Watercare Services Ltd

Huia WTP Site Selection

DRAFT Addendum to the Shortlist Site Development Report (2016)

May 2017

Figure 3 – Manuka Rd Revised Layout

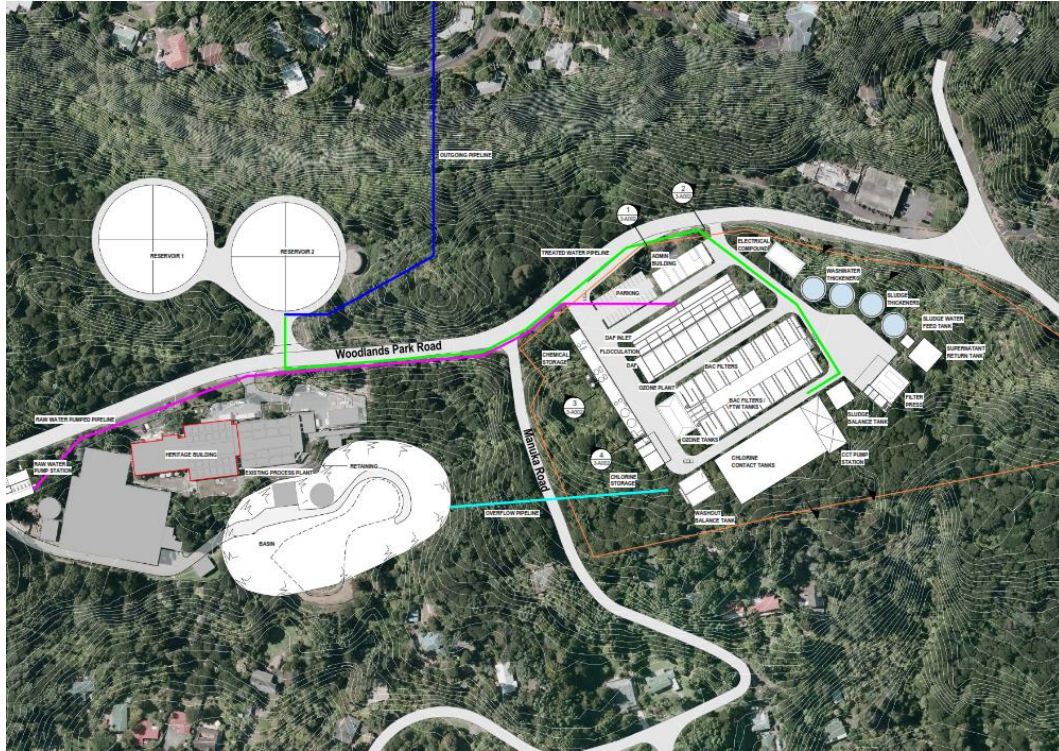
As shown in Figure 3 below, the increased capacity is accommodated on the site, however it is too constrained to provide an allowance for an additional future treatment process block.

The layout remains largely unchanged from that presented in the Shortlist Development Report as the site slopes steeply along the west, south and east sides – constraining layout options.

While the lowering the reservoirs TWL to 120 mRL (from 128 mRL), reduces pumping power consumption for sites requiring treated water pumping, the Manuka Road site will not see any benefit in lowering the TWL of the reservoirs due to requiring raw water pumping . Lowering the reservoirs would only increase construction costs due to the additional depth of the reservoirs and valve chambers.

Due to limited site area and challenging topography, there is reduced scope on site to provide buffer zones/separation

Overall, the design criteria changes that can be accommodated and/or are applicable, result in little change to the site as presented in the Shortlist Development Report. Thus, the assessments presented in that report are still applicable.

Figure 4 – Existing Site Revised Layout

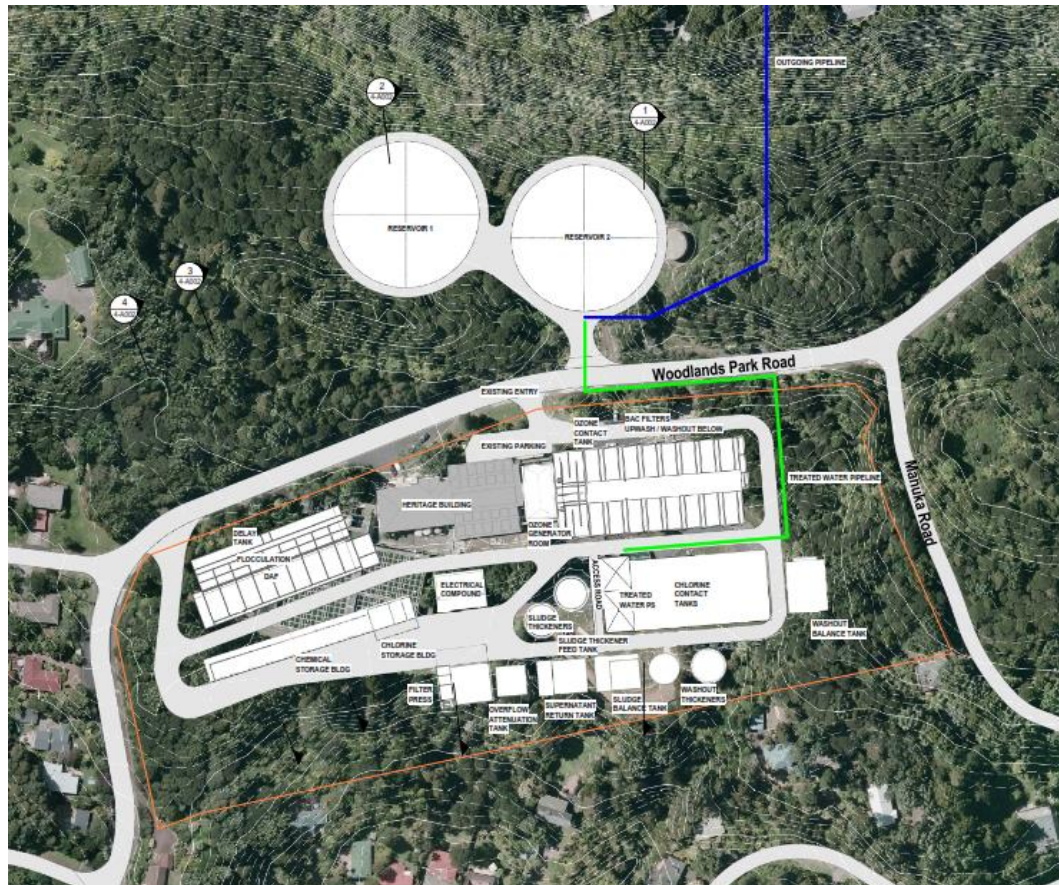
As shown in Figure 4 below, the increased capacity is accommodated on the site, however as with Manuka Road the site is too constrained to provide an allowance for an additional future treatment process block.

The layout remains largely unchanged from that presented in the Shortlist Development Report as the site slopes steeply along the south and east sides – constraining layout options.

Lowering the reservoirs TWL to 120 mRL (from 128 mRL) would reduce pumping power consumption. However, due to the constraints of the sites the reservoirs cannot be located elsewhere and thus a reduction of TWL would require the reservoirs to be largely constructed below ground level. Aside from the cost implications, below ground reservoirs have additional health and safety implications associated with deep pipework/valves and their access chambers.

Due to limited site area and challenging topography, there is reduced scope on site to provide buffer zones/separation

Overall, the design criteria changes that can be accommodated and/or are applicable, result in little change to the site as presented in the Shortlist Development Report. Thus, the assessments presented in that report are still applicable.
